**SPARTANBURG COMMUNITY COLLEGE – TYGER RIVER BUILDING COSMETOLOGY  
RENOVATION**

**OSE PROJECT # H59-N306-JM | ARCHITECTS PROJECT # 653251**

## RESPONSE TO PRE-BID QUESTIONS

**1 UPPER LEVEL - FLOOR PLAN**  
A2.1.2 1/8" = 1'-0"

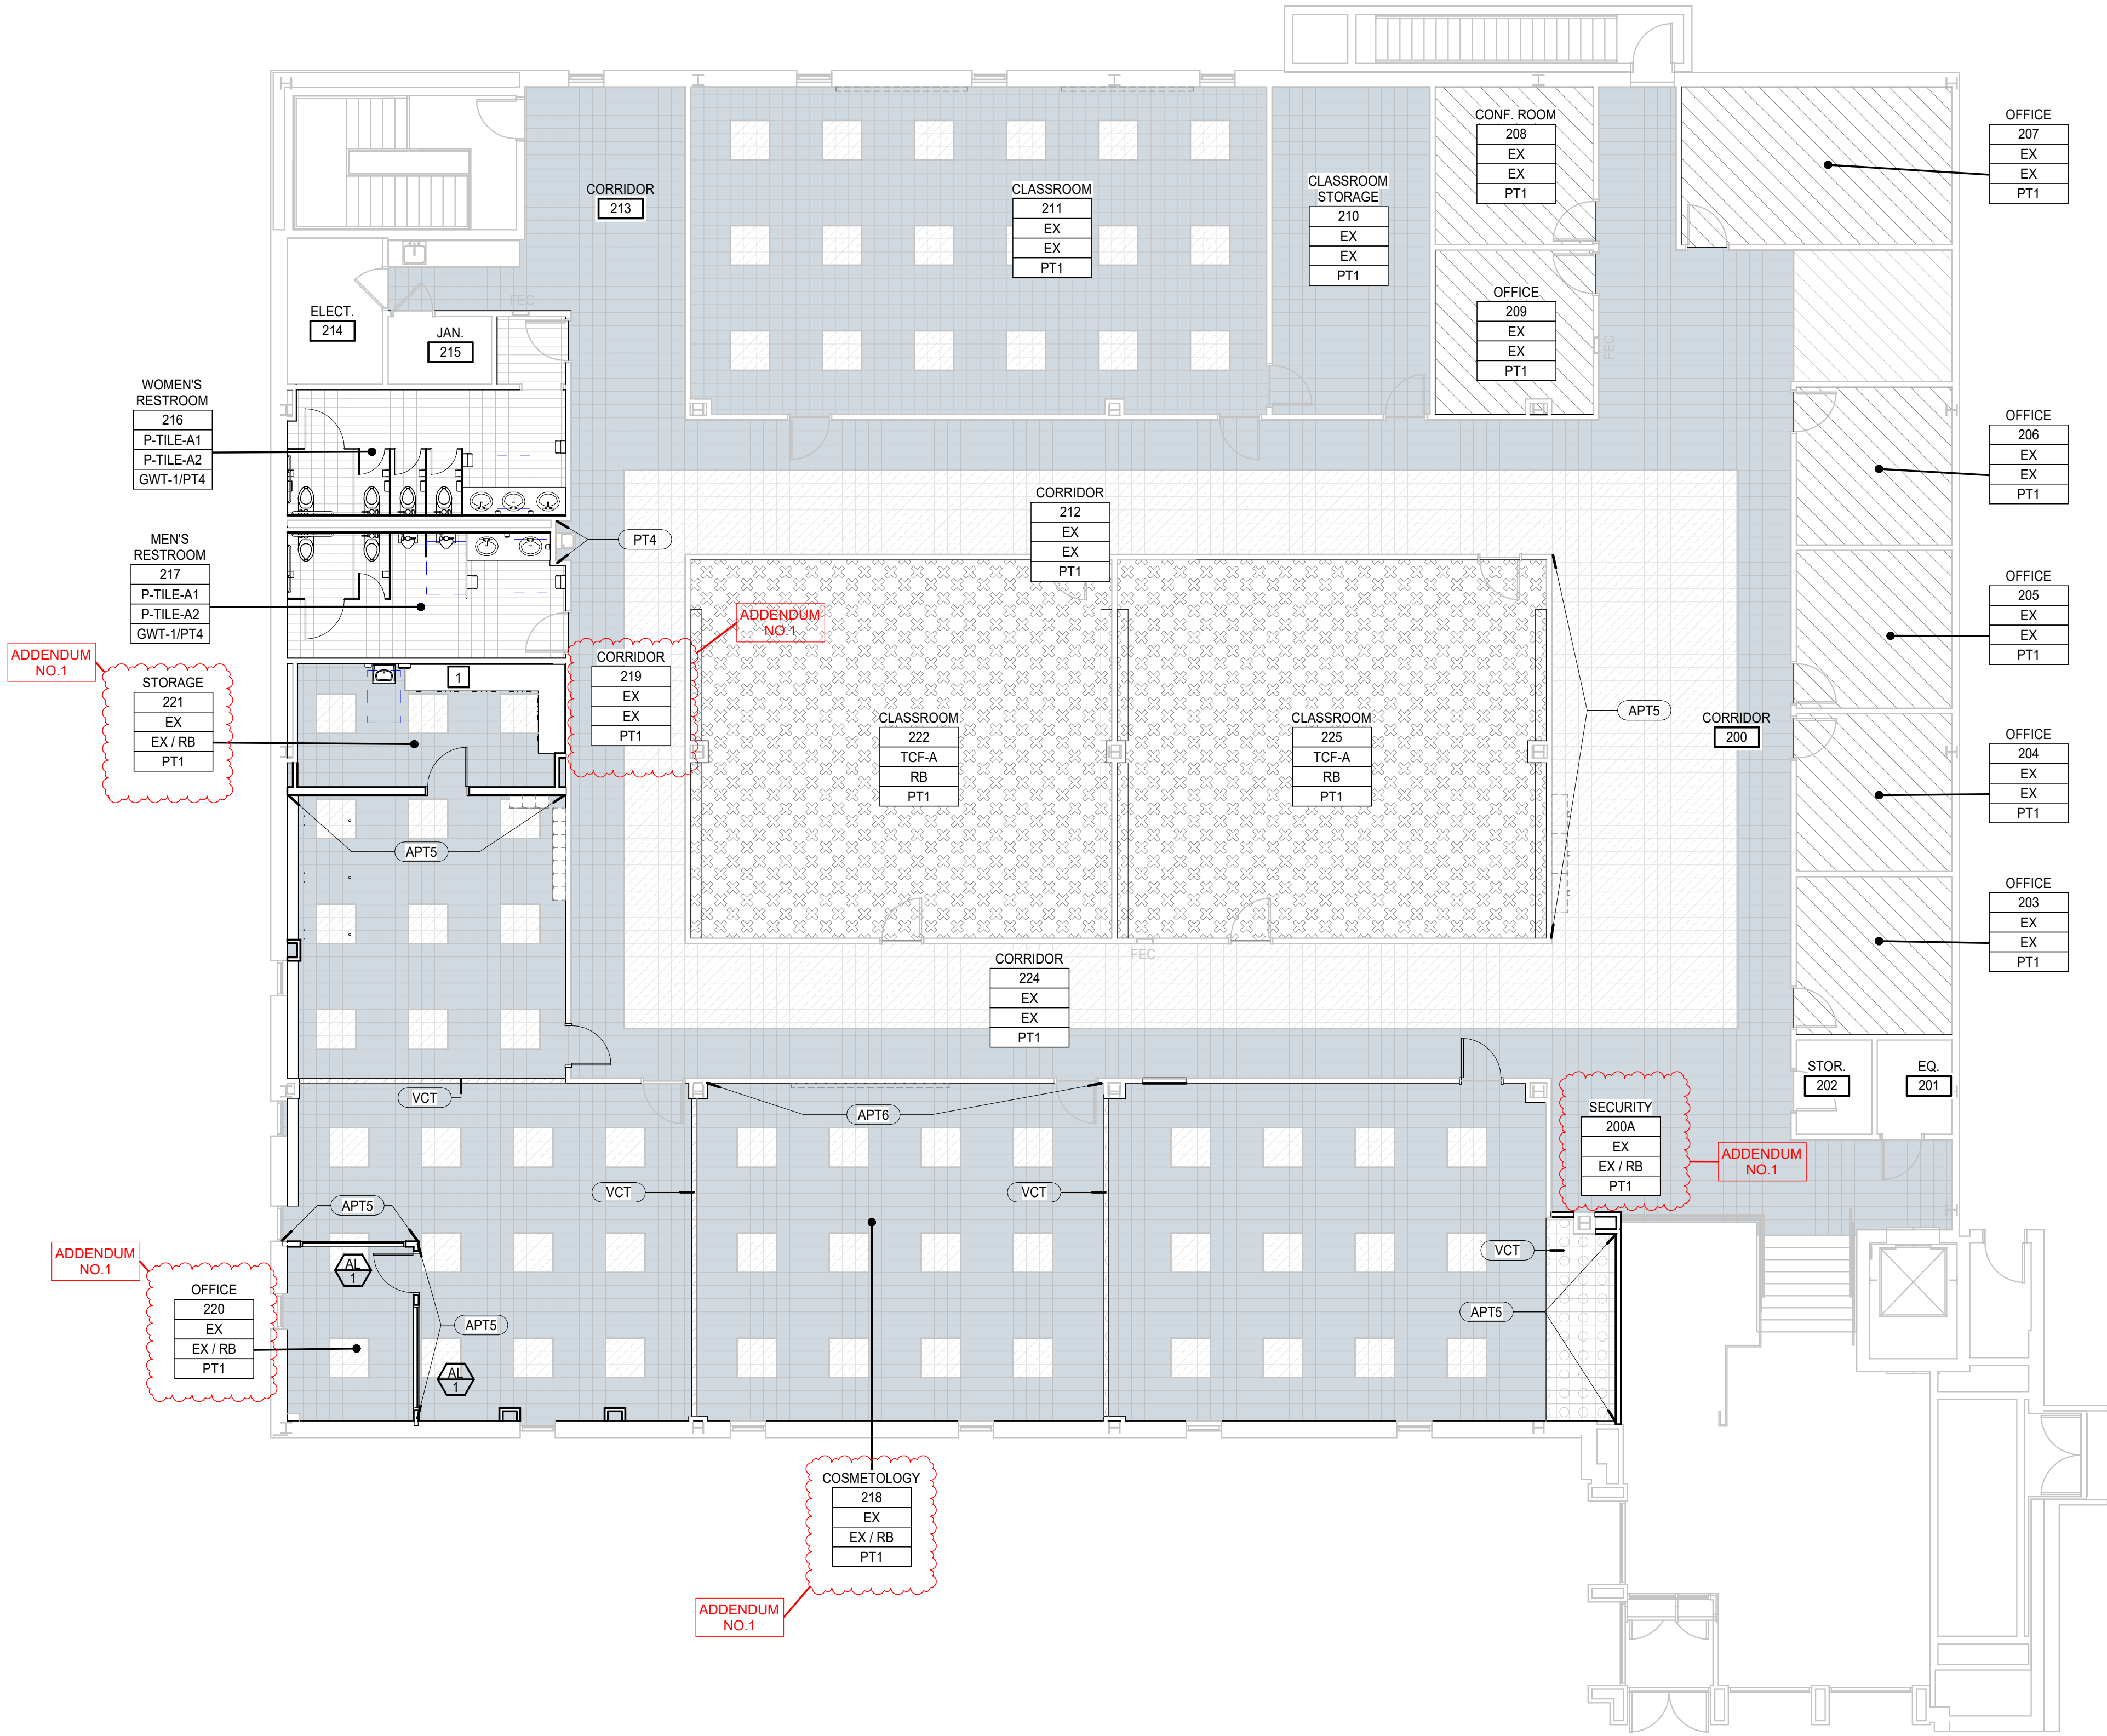
17. The revision cloud on sheet A2.1.2 in room 211 is a legacy revision from a permitting comment response, the cloud has been removed from the revised sheet in addendum no.1.

4 CORRIDOR 212 - S

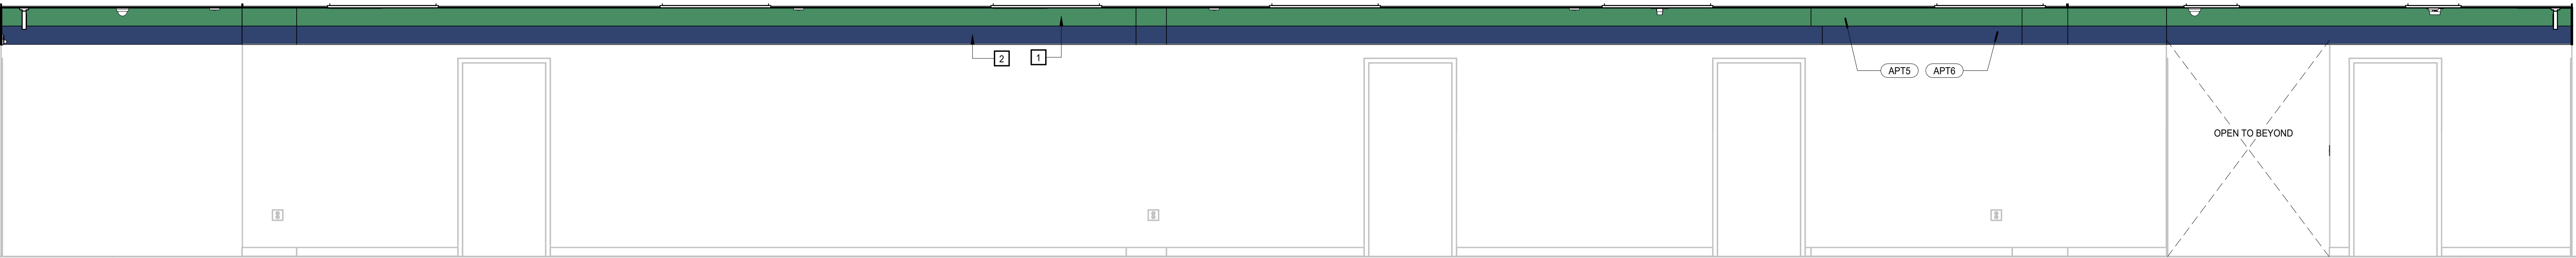
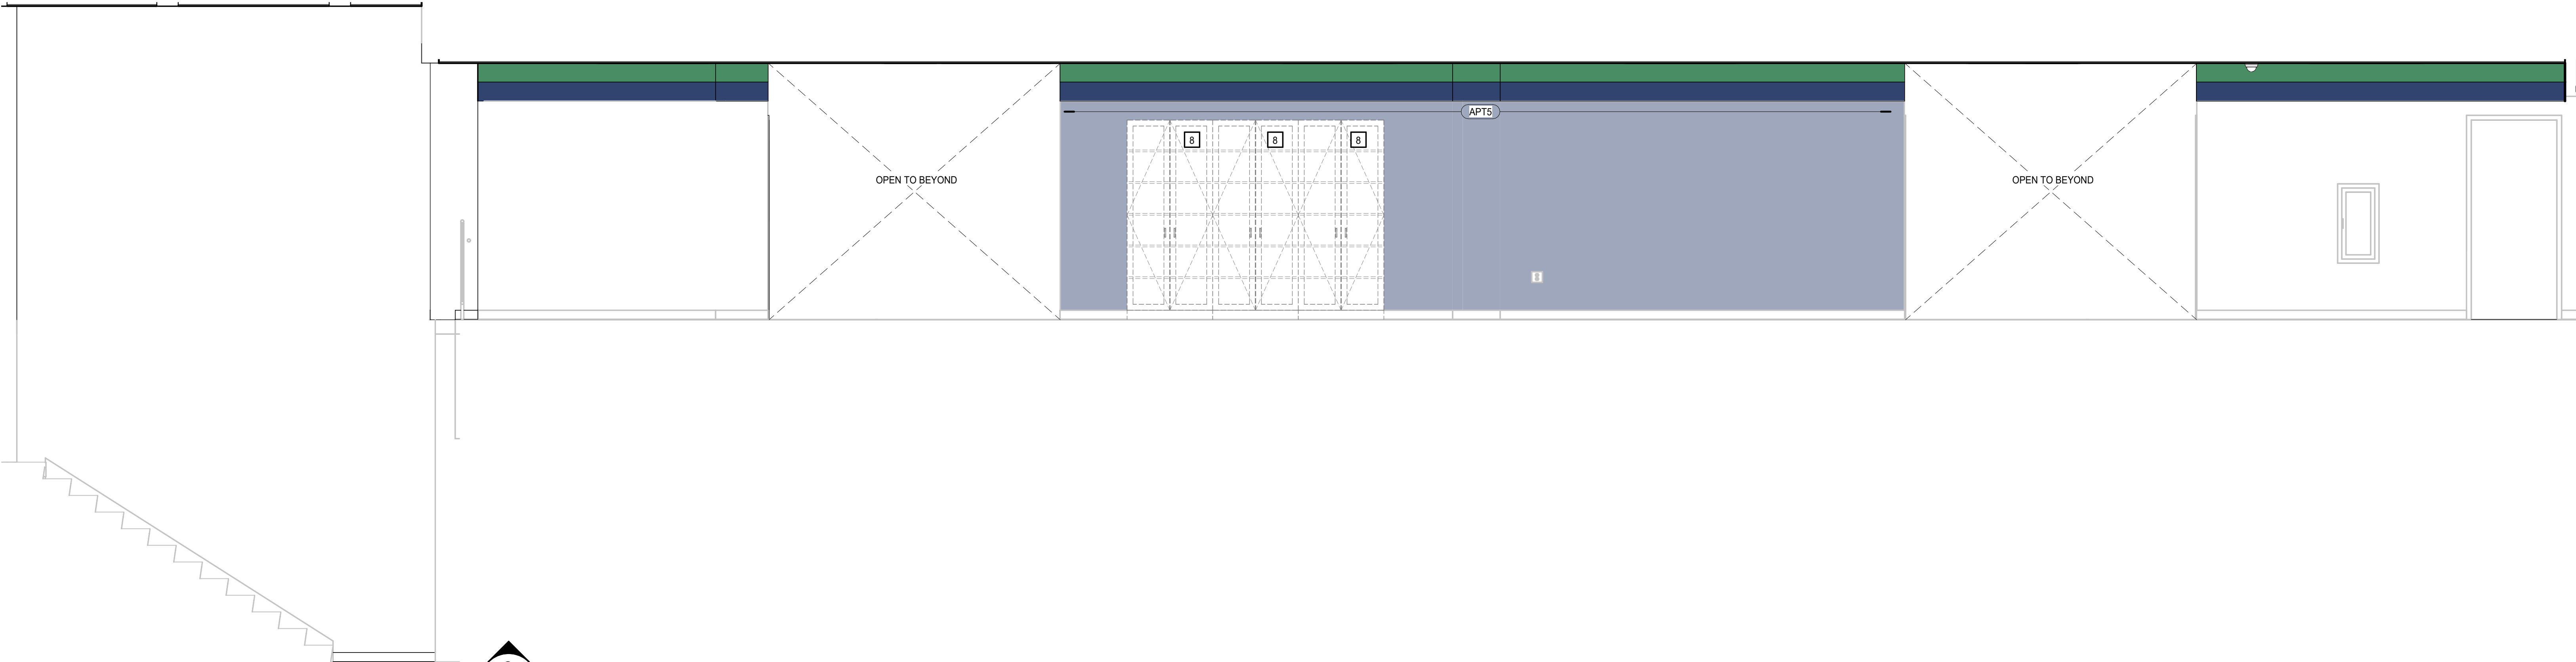
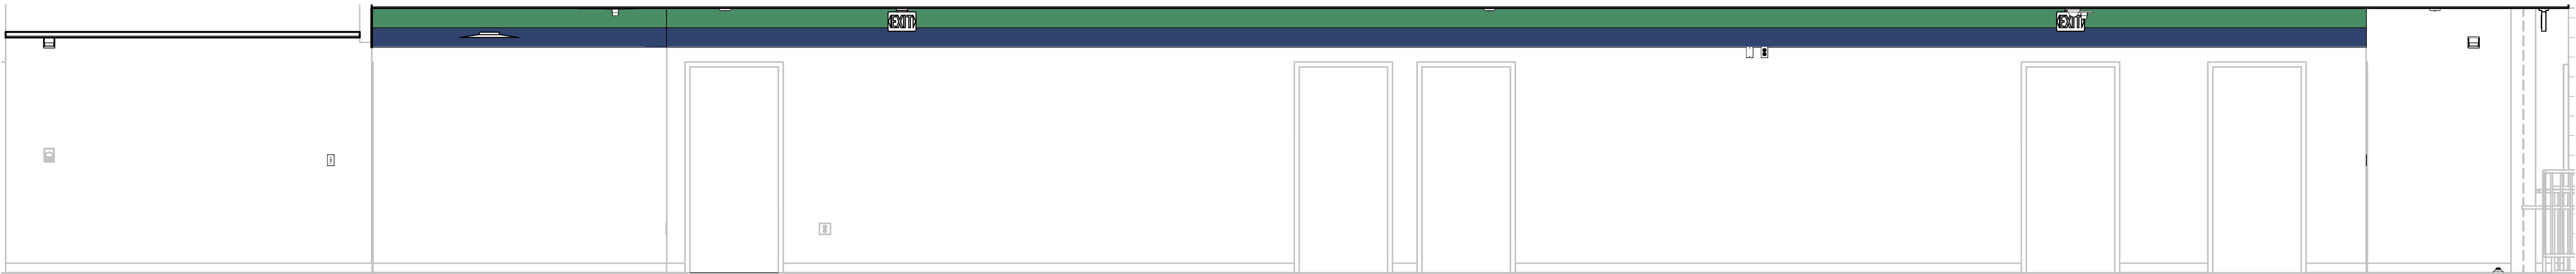
7. Accent paint bands in the corridors shall be 8" in width, interior elevations on sheets A4.2.1 and A4.2.2 have revised and included in Addendum No.1.

12. Rubber wall base has been added to the wood knee/chase walls, see revised sheet A4.2.2.
13. Provide rubber wall base on all new interior partitions and patch rubber wall base where existing walls were demolished.

**1 ENLARGED PLAN - 221 STORAGE**  
A2.1.2 | A7.2.1 3/8" = 1'-0"

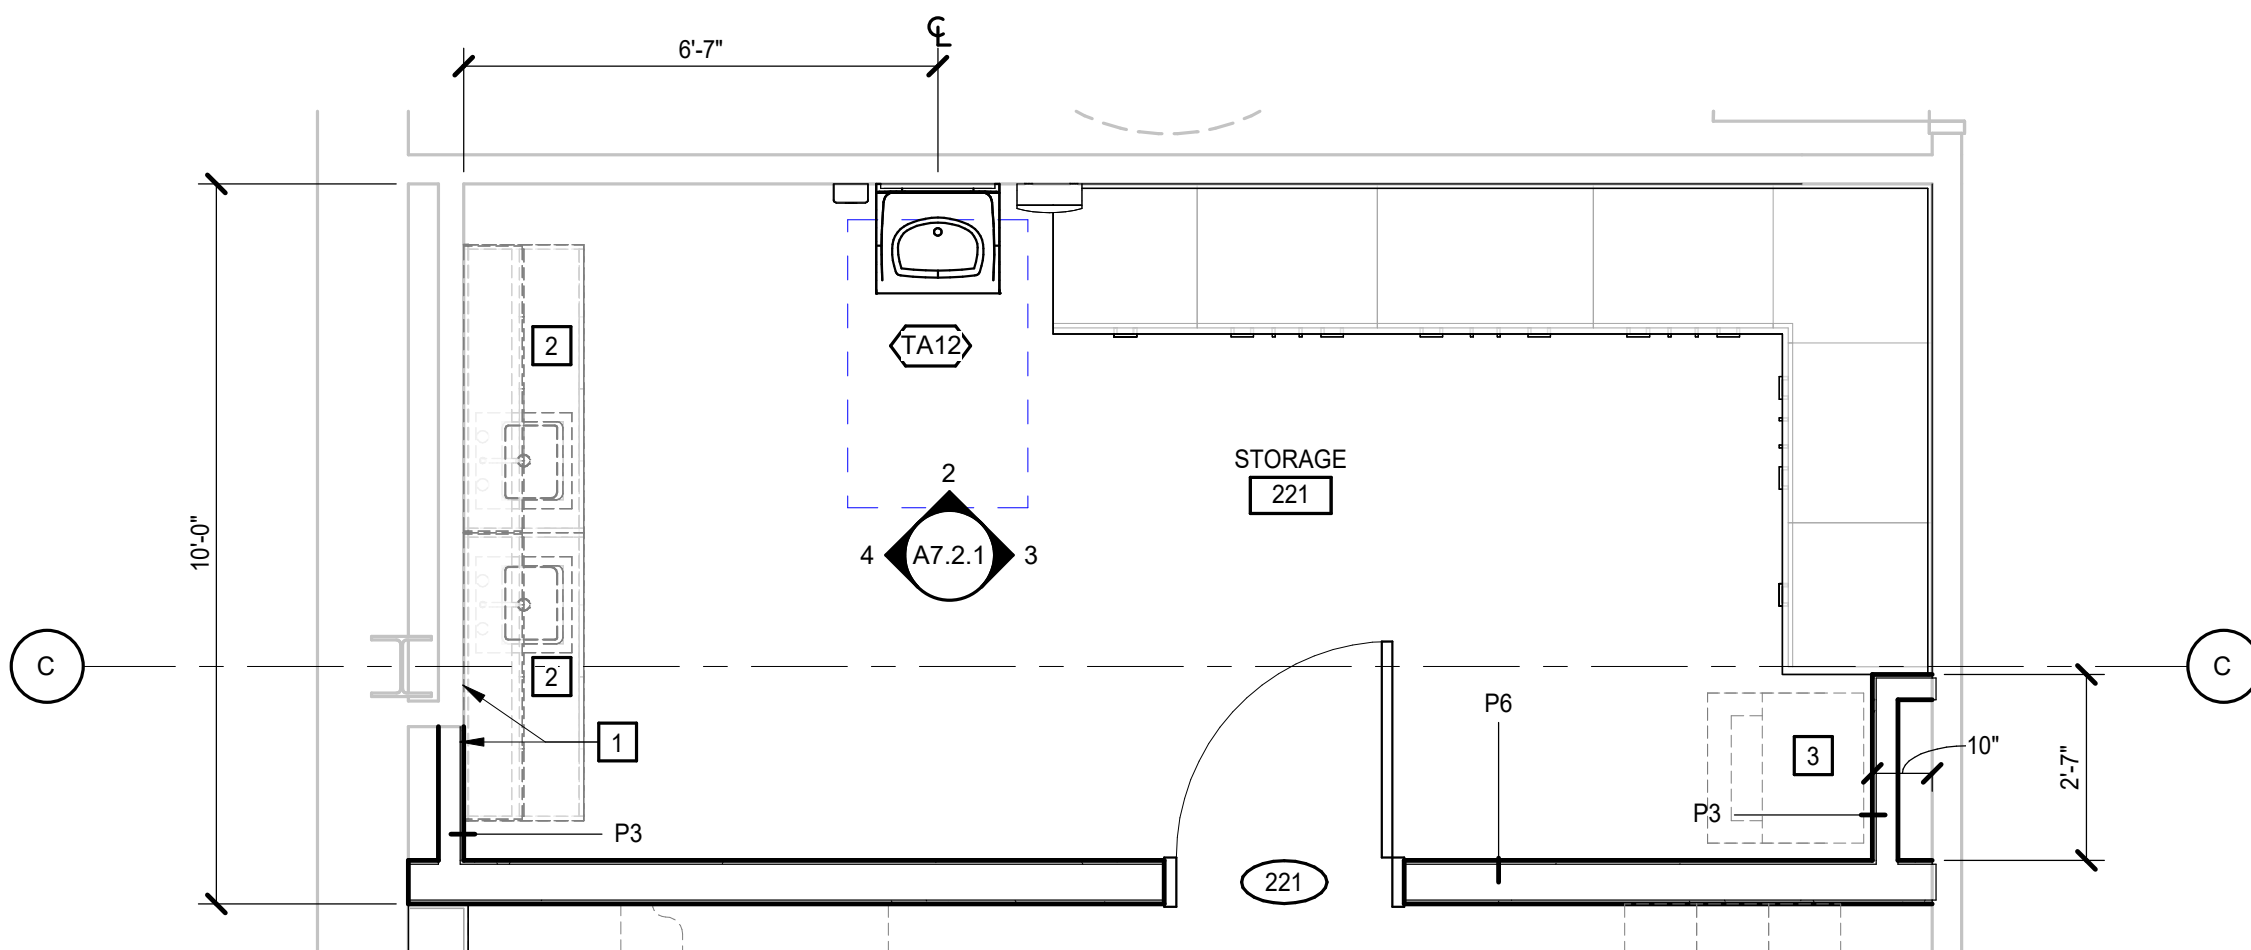
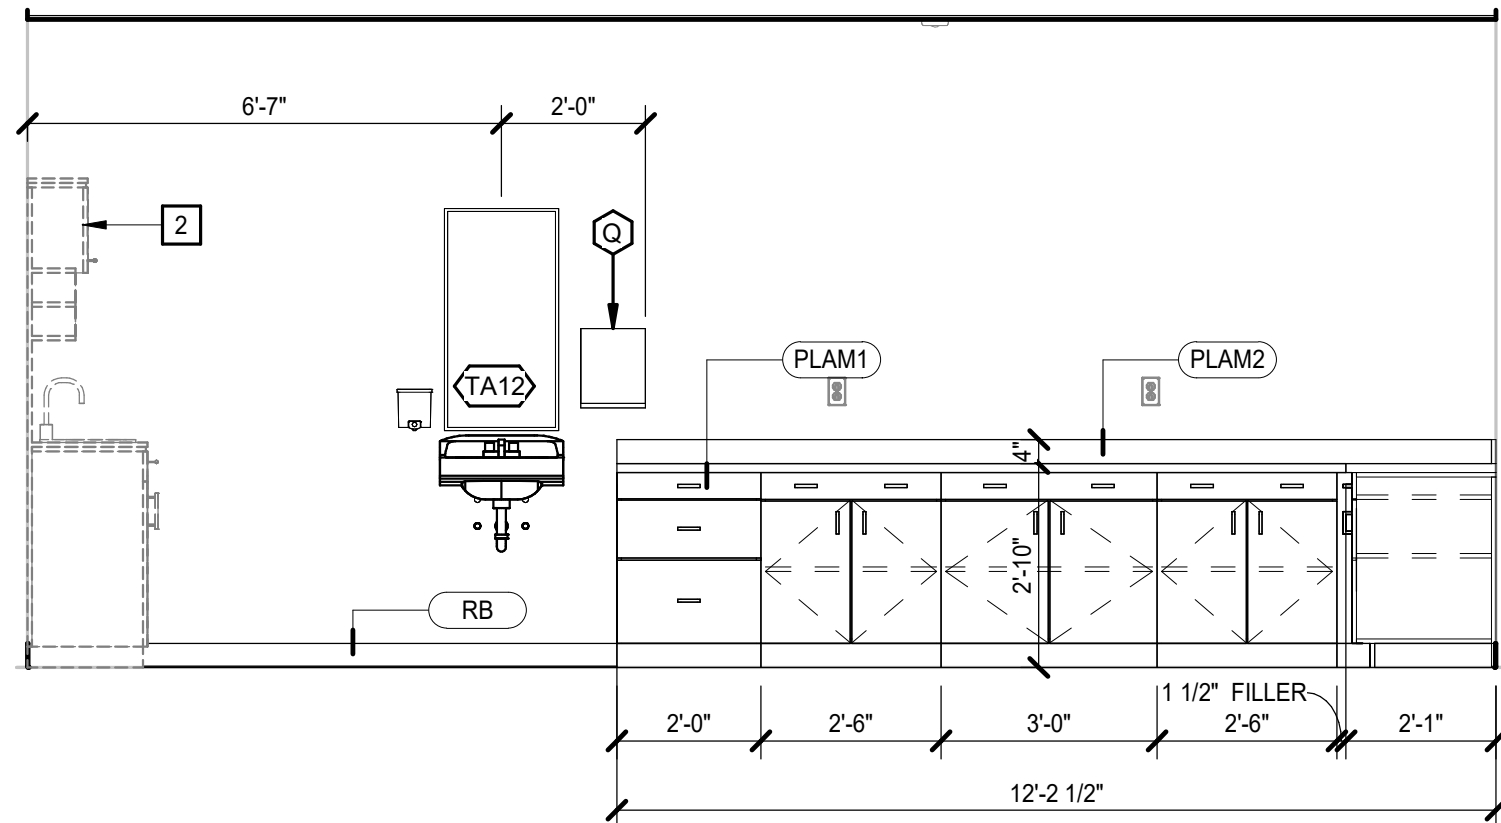
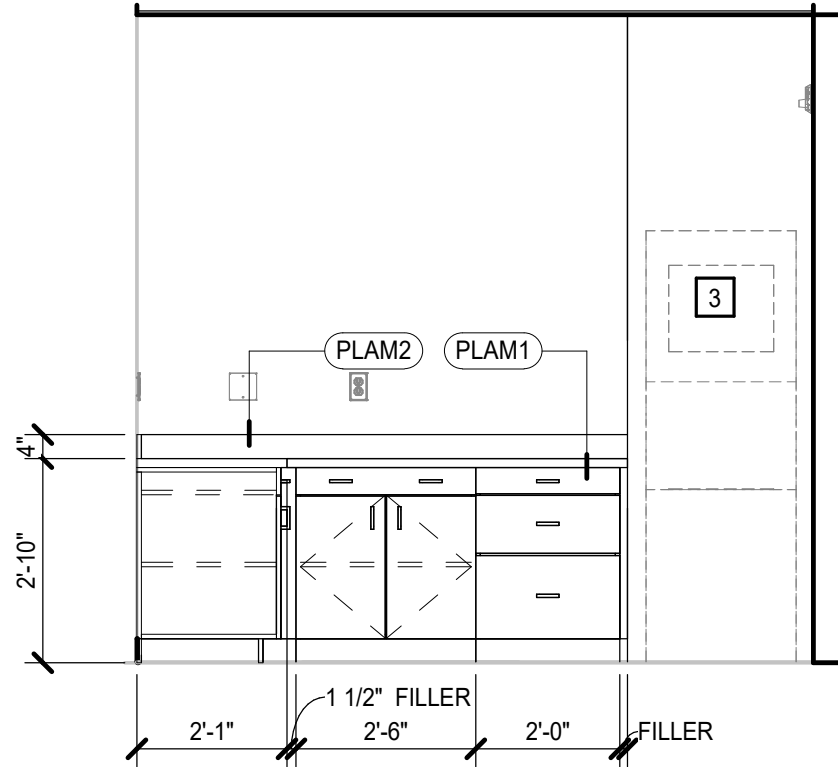
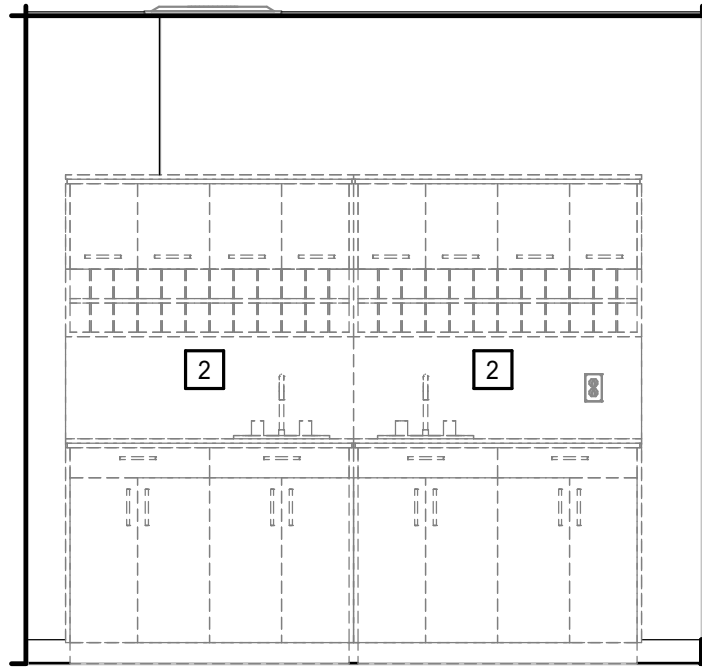
20. Stacked washer and dryer is to be provided by the contractor and installed by the contractor, keynote #3 on A7.2.1 has been revised in addendum no.1.
